Project	Creekview Ranch School Campus Expansion – Site Package
Client	Dry Creek Joint Elementary School District
Date	07/21/2026
Project Number	Y2514.00
Agency Number	02-123892 Inc. 01

End of Addendum Number 03

C7.2
AD3.09

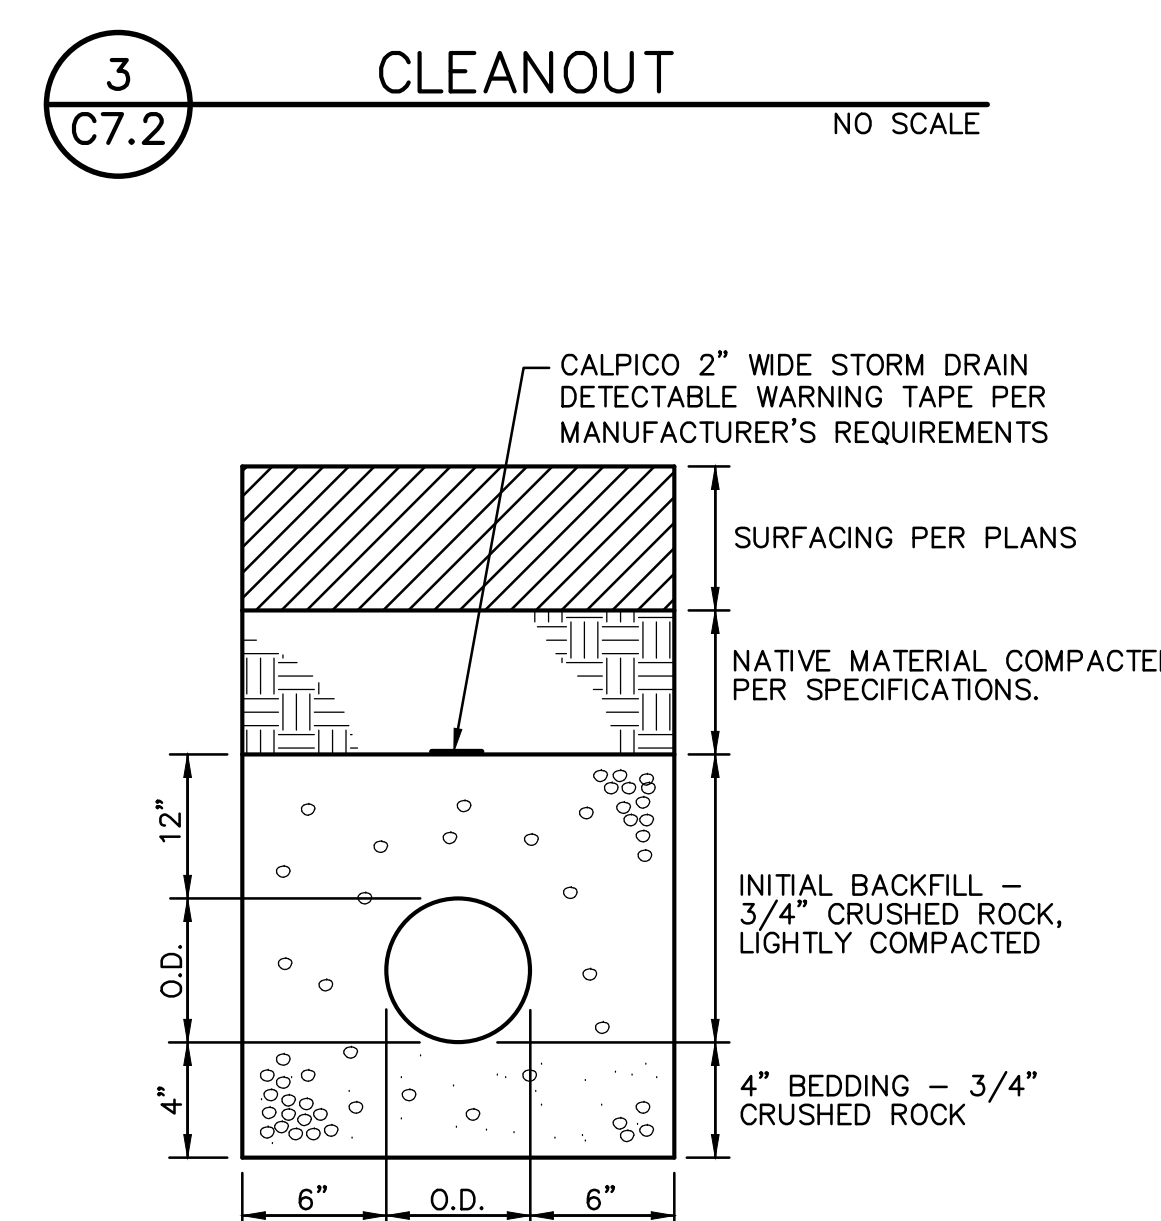
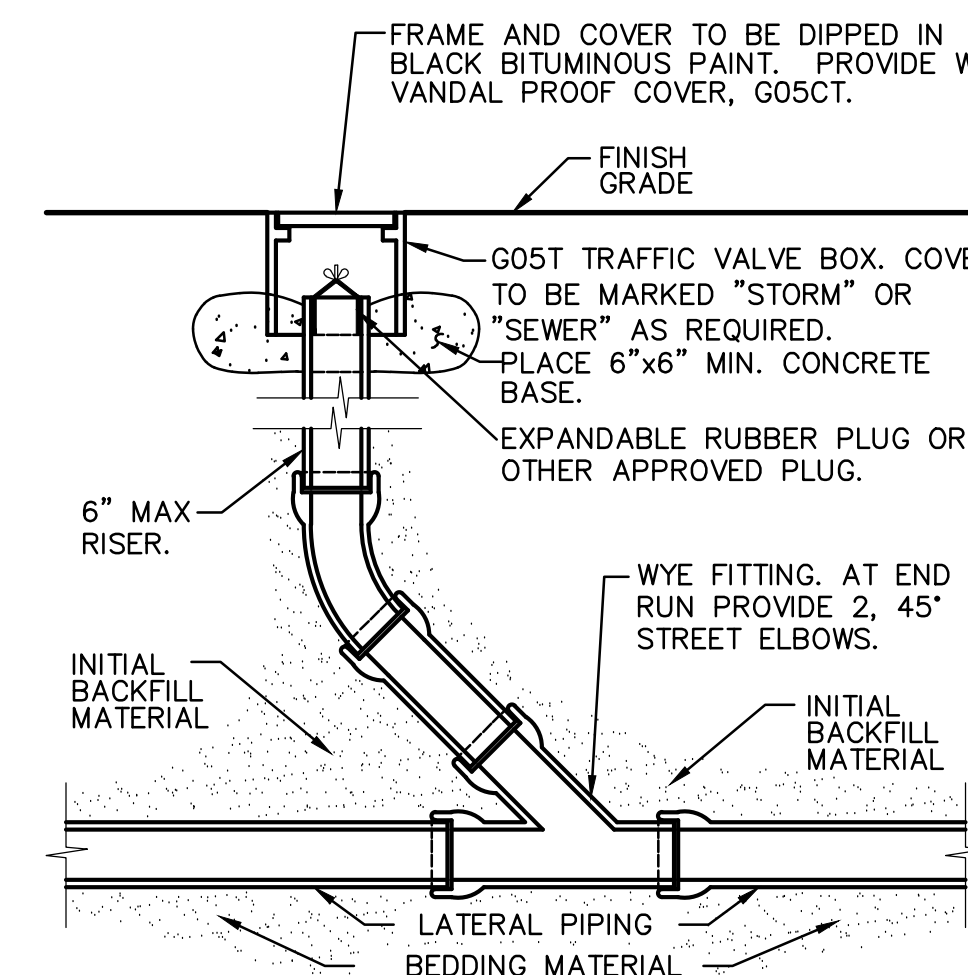
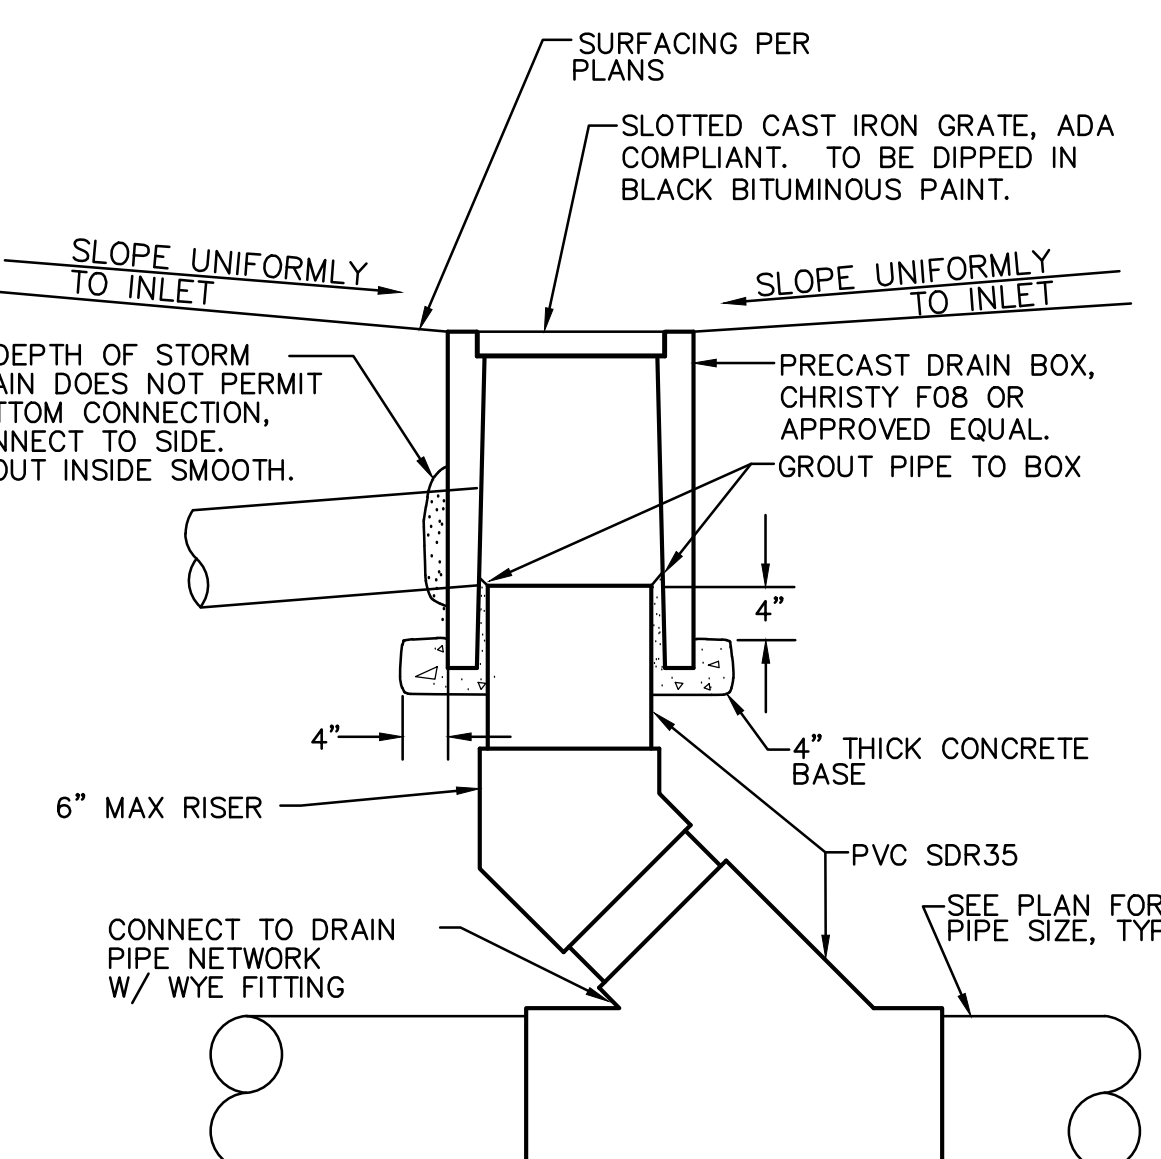
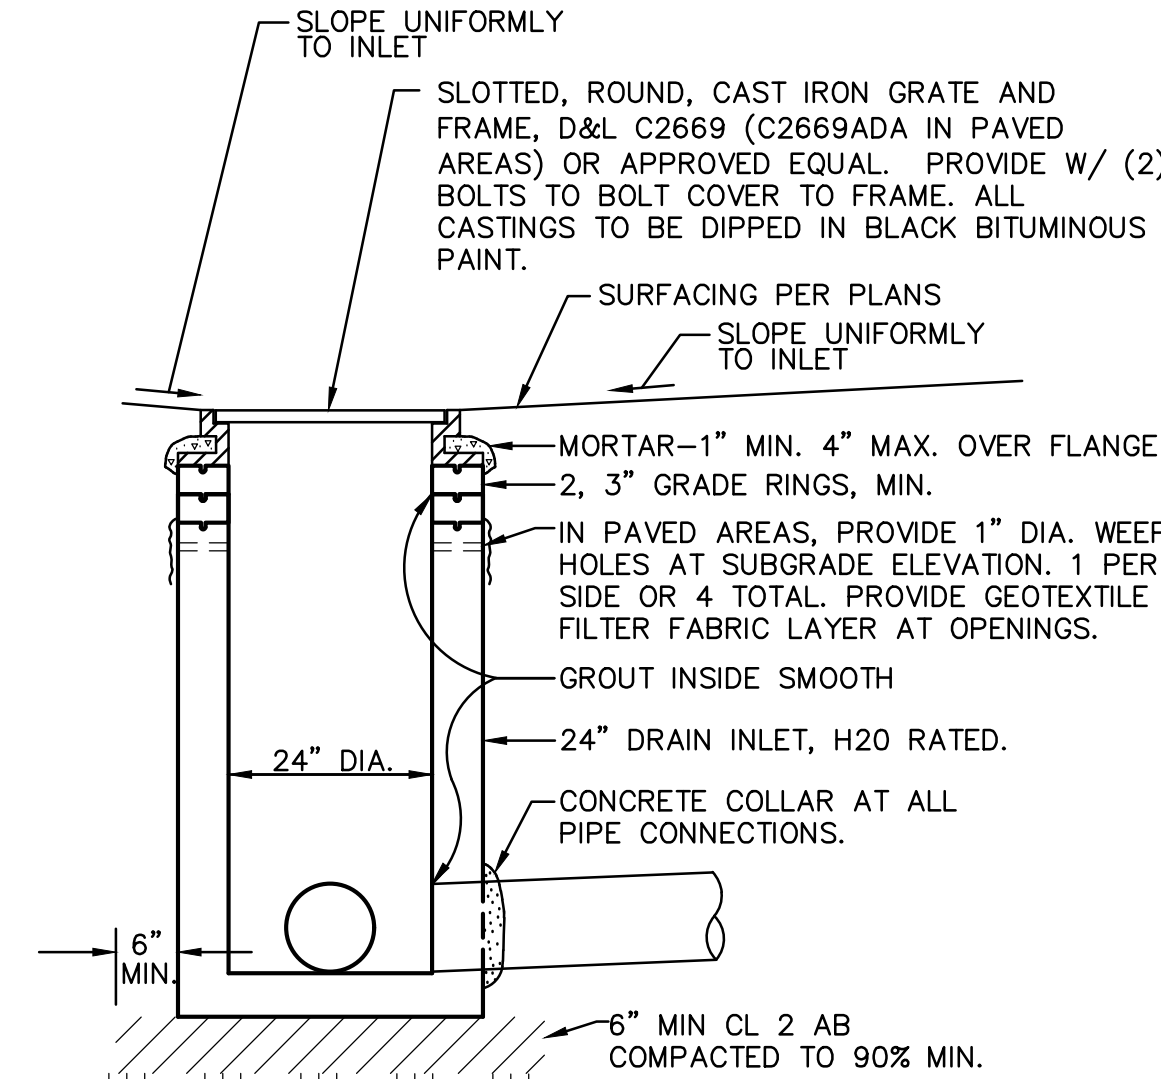
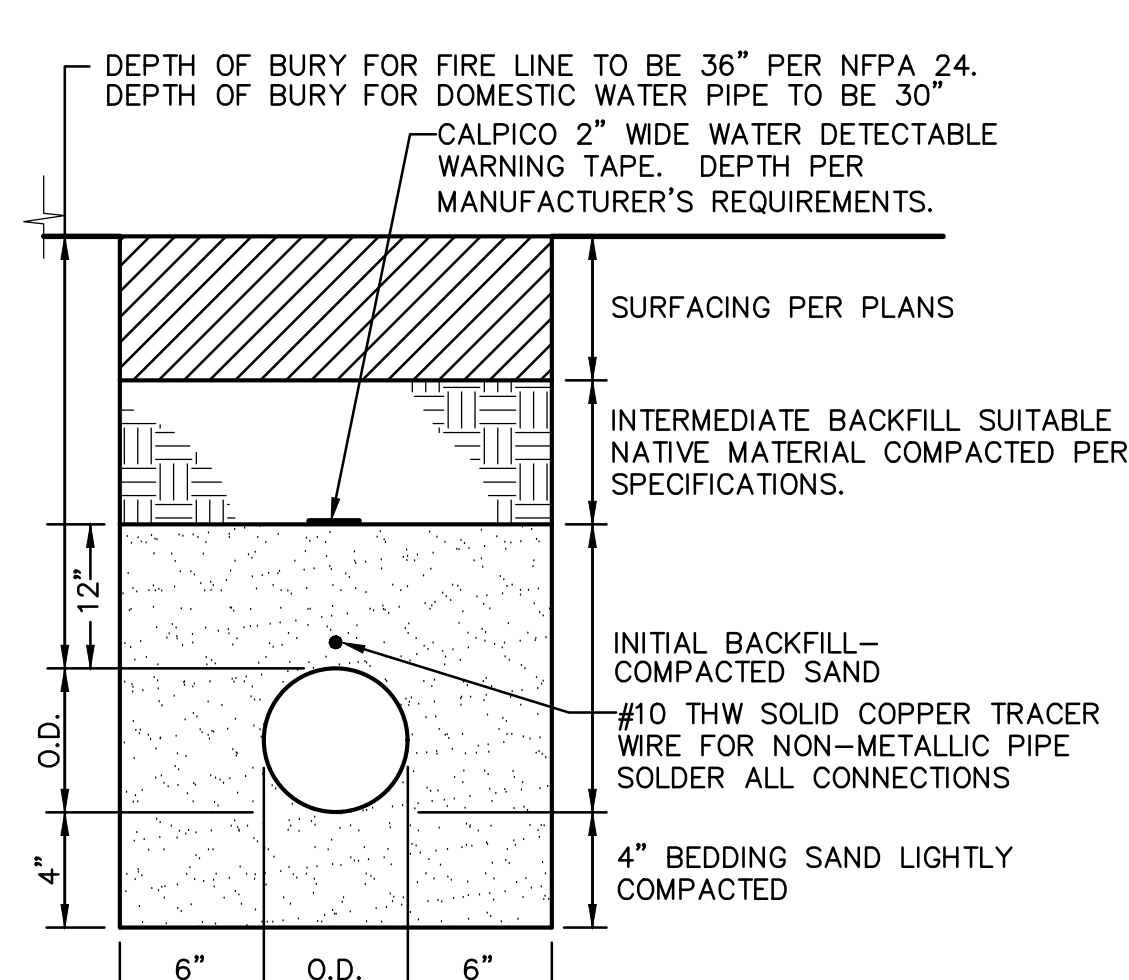
Q#1: Detail 9/A105 calls for out "mow strip per 13/C6.1 where occurs on plans". Sheet C6.1 is the erosion control plan and doesn't have a detail 13. We're assuming a mow strip is required under the new fencing to match existing conditions. Please confirm a mow strip is required under all new fencing and provide detail.

Q#5: Please provide a detail for the downspout to storm drain connection per note #41 on sheet C3.2

Q#6: Please provide a detail for the splash blocks, reference drainage note #42 on sheet C3.2

Q#7: Please provide concrete & connection details along with manufacturer model & grate type for the trench drain shown in between the new buildings on sheet C3.2

R#1: New mow strip is required under new fencing in some areas – keynote 18 was added on C2.1 and C2.2 to show locations of new mow strip and Detail 15/C7.2 been added, see attached sheet.

R#5: Detail 16/C7.2 been added, see attached sheet.

R#6: Detail 17/C7.2 been added, see attached sheet.

R#7: Detail 18/C7.2 been added, see attached sheet.

- AD3.07** Sheet C2.2 – Grading Plan
 - Added Keynote 18 and placed on all views
- AD3.08** Sheet C3.2 – Utility Plan
 - Added detail references for keynotes 41, 41, and 44, and added sewer note 55.
- AD3.09** Sheet C7.2 – Details
 - Added details 15, 16, 17, and 18.
